**PLANNED UNIT DEVELOPMENT
& SUBDIVISION STAFF REPORT****Date: July 20, 2017****DEVELOPMENT NAME**

Rangeline Crossing III Subdivision

Planned Unit Development Approval to amend a previously approved Planned Unit Development to allow shared access between multiple lots, and Subdivision Approval to create 3 lots.

SITE PLAN

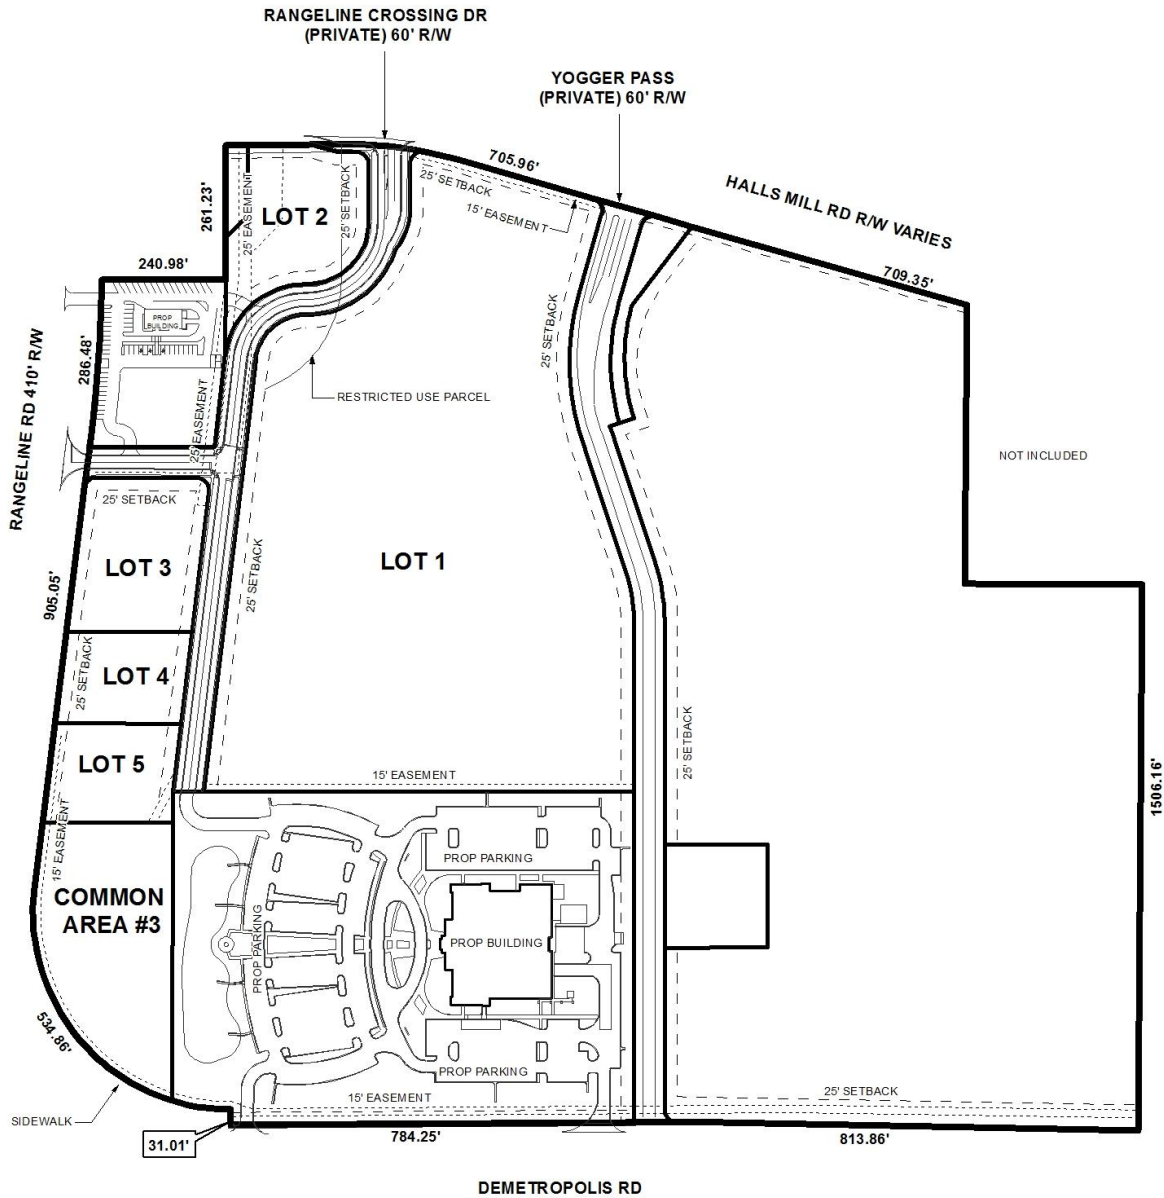
The PUD site plan depicts Lot B as having a fast food restaurant developed on the site with compliant parking and queuing spaces; however the dumpster is located with the 25' minimum building setback line. The site plan should be revised to depict the relocation of the dumpster so that it is not located within the setbacks. The site plan should also be revised to include a note stating "full tree planting and landscape requirements will be met and in compliance with Section 64-4.E of the Zoning Ordinance".

Several drainage, access and utility easements are depicted on the preliminary plat and the PUD site plan. A note should be placed on both the plat and the site plan stating that structures that are not associated with the purpose of the easement shall not be placed within any easement.

Sidewalks are depicted on the site plan and should be retained on any future plans.

It should be pointed out that the newly proposed PUD site plan does not reflect the previously approved site plan and plat in that the layout of the proposed private road (Rangeline Crossing Drive) has changed. The new proposed location of the private road depicts significant changes that effect Lots 1 and 2 of the Rangeline Crossing Subdivision approved on May 4th. As such, the previous approved plat must be revised to reflect the new location of the proposed private road. Therefore the current applications must be heldover to allow a revised application to be submitted for subdivision approval to allow consistency among the plats and site plans.

1. submission of a revised subdivision application to address the new location of the proposed private road and the resulting changes to Lots 1 and 2.
2. revision of the site plan to remove the dumpster outside of the 25' minimum building setbacks;
3. add a note to the site plan stating full tree planting and landscape requirements will be met and in compliance with Section 64-4.E of the Zoning Ordinance; and
4. add a note to both the plat and the site plan stating that structures that are not associated with the purpose of the easement shall not be placed within any easement.

- 4) placement of a note on the site plan stating that structures that are not associated with the purpose of the easement shall not be placed within any easement;
